SECTION 00 91 01

**ADDENDUM NO. 1**

This document includes requirements that clarify or supersede portions of the Request for Proposal. This Addendum is a Contract Document.

**BUILDINGS 5 & 6 RENOVATIONS**  
 San Mateo County Community College District

**1 THIRD FLOOR PLAN - POWER**  
SCALE: 1/8"=1'-0"

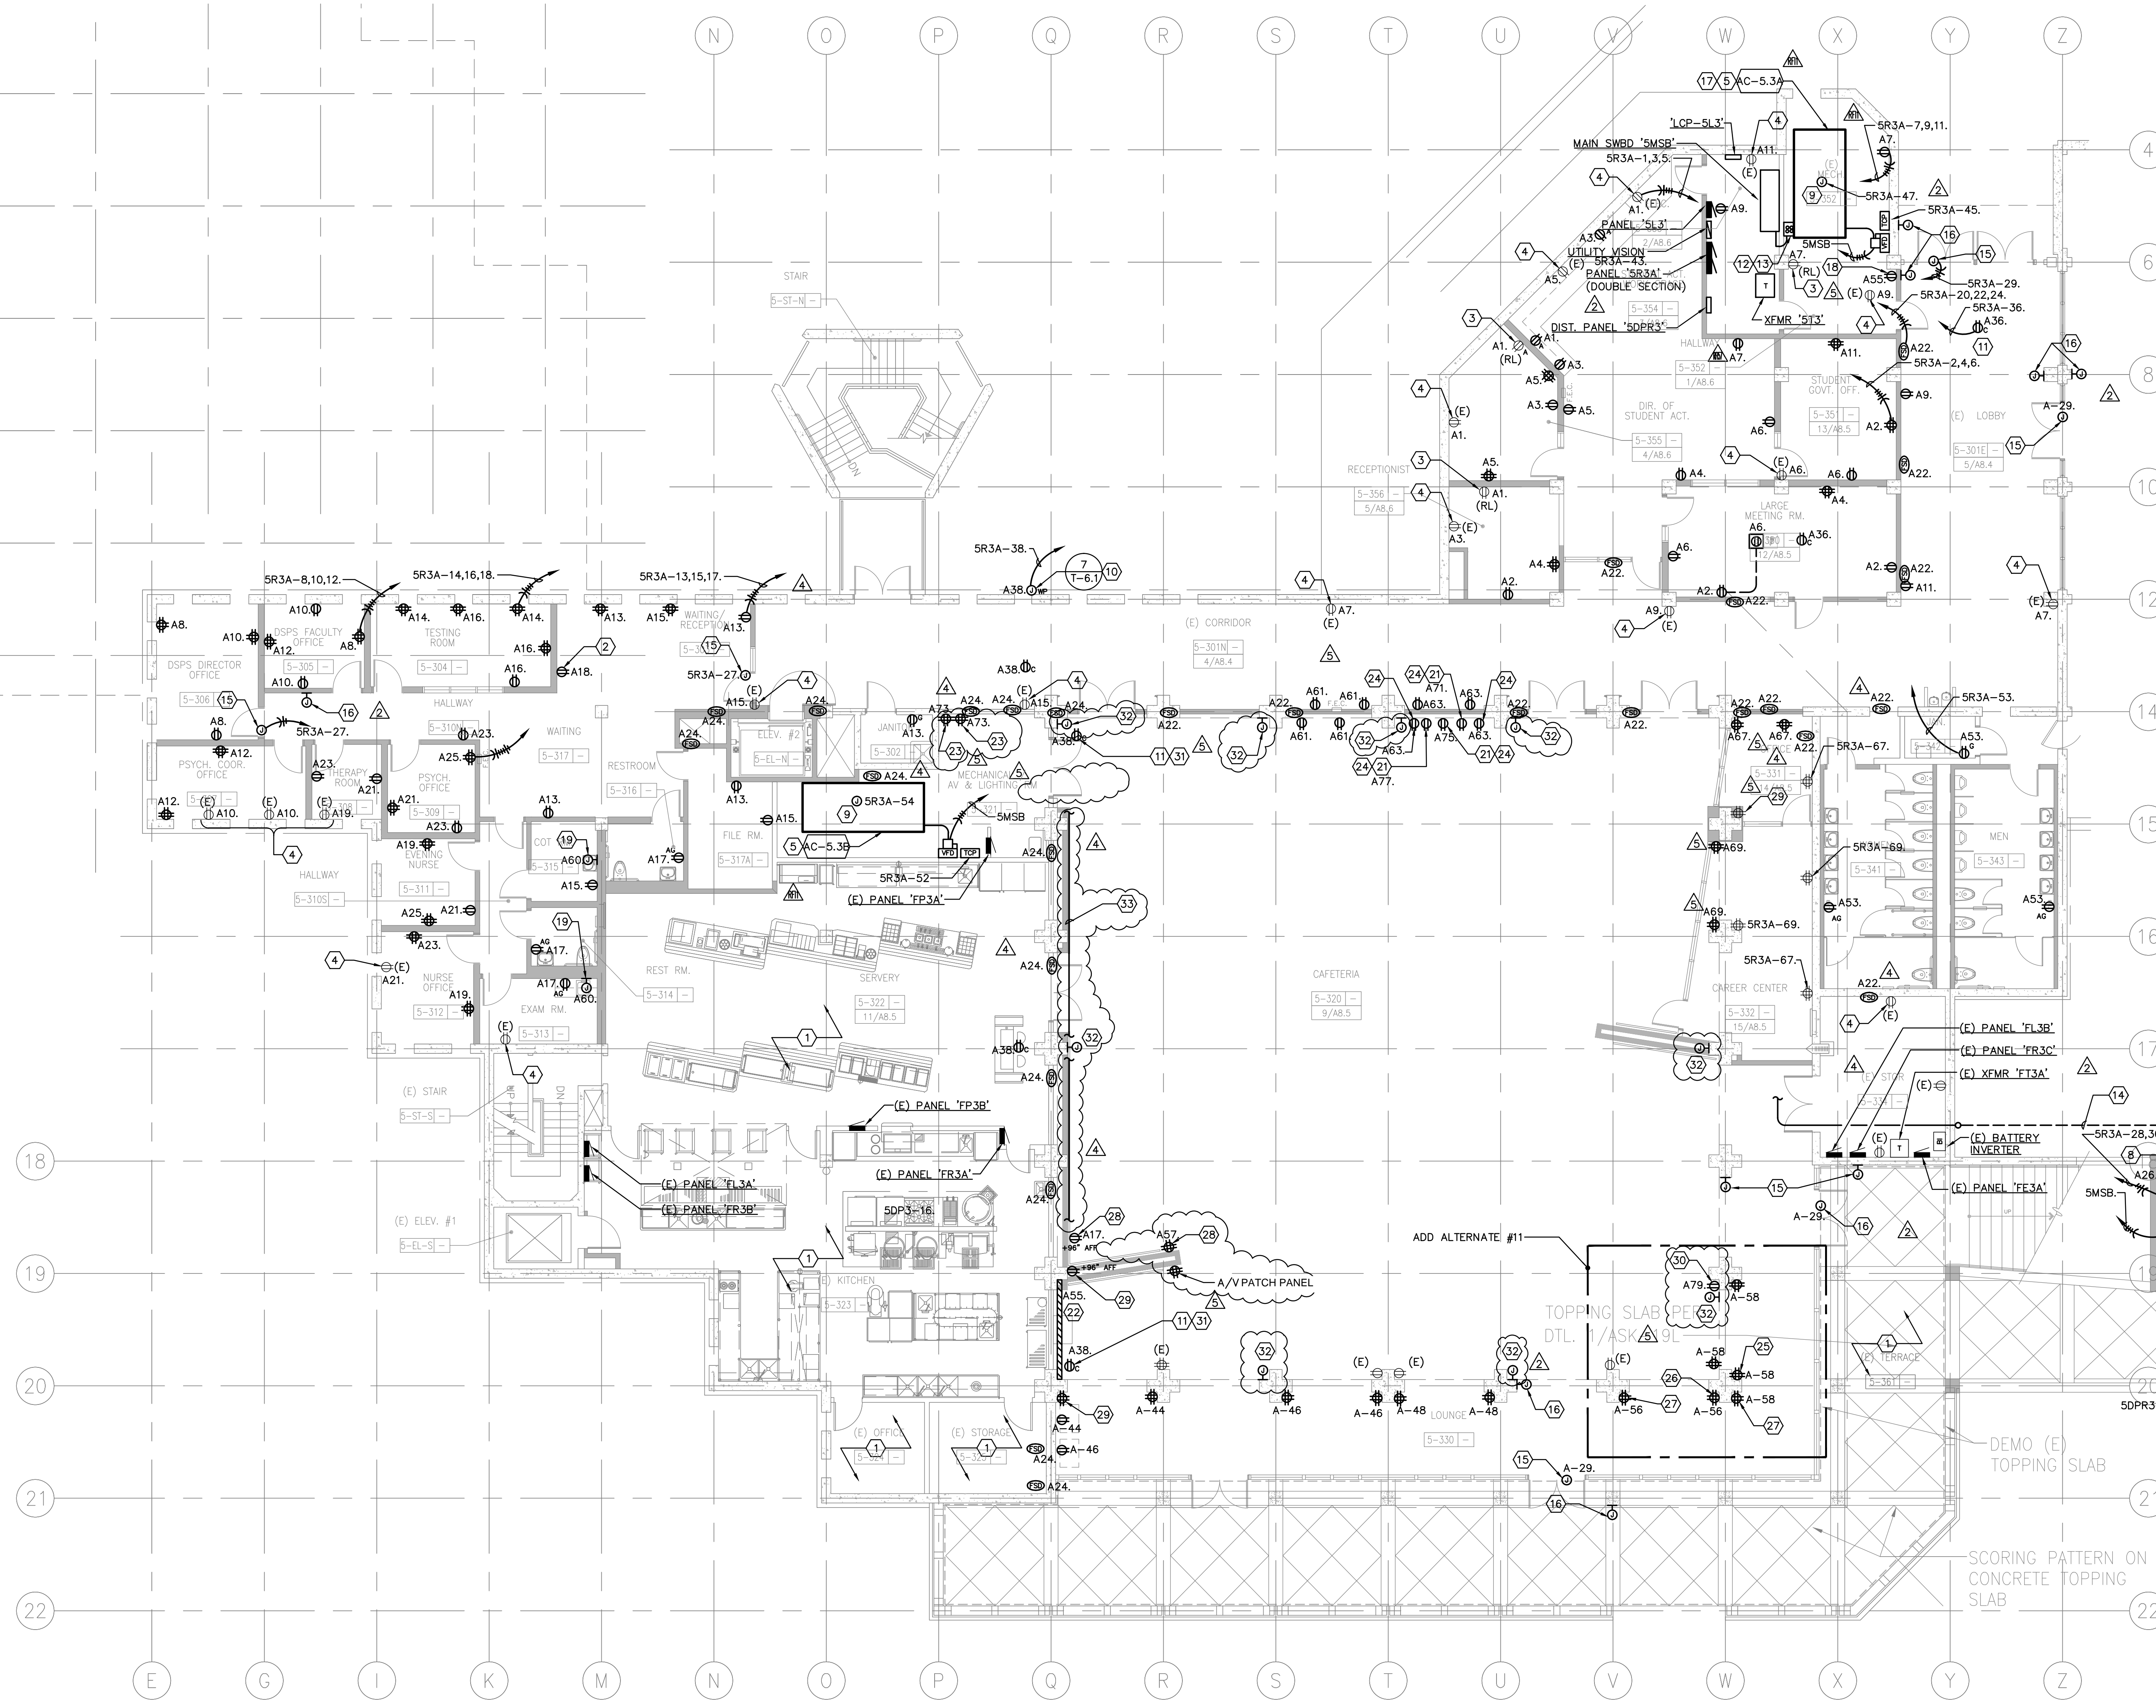
14. Revise circuiting in Career Center
14. Drawing E3.3 – Third Floor Plan – Power
- A. Modified drawing E3.3 as shown on attached revised Drawing E3.3:

1. Revised Sheet Note 30.
    2. Added Sheet Notes 32 and 33.
    3. Revised location of quad receptacles for A/V rack in A/V room.
    4. Deleted power for track lighting lowering device in A/V room.

5. Added junction boxes for A/V speakers.
    6. Added power for sub-woofer.
    7. Added quad receptacle for second A/V controller.
    8. Added conduits for A/V cabling.

9. Substitute the words “A/V Patch Panel #2” for “A/V Patch Panel“ shown on drawing
15. Drawing T4.3 – Technology Third Floor.
- A. Modified drawing as shown on attached revised Drawing T4.3:
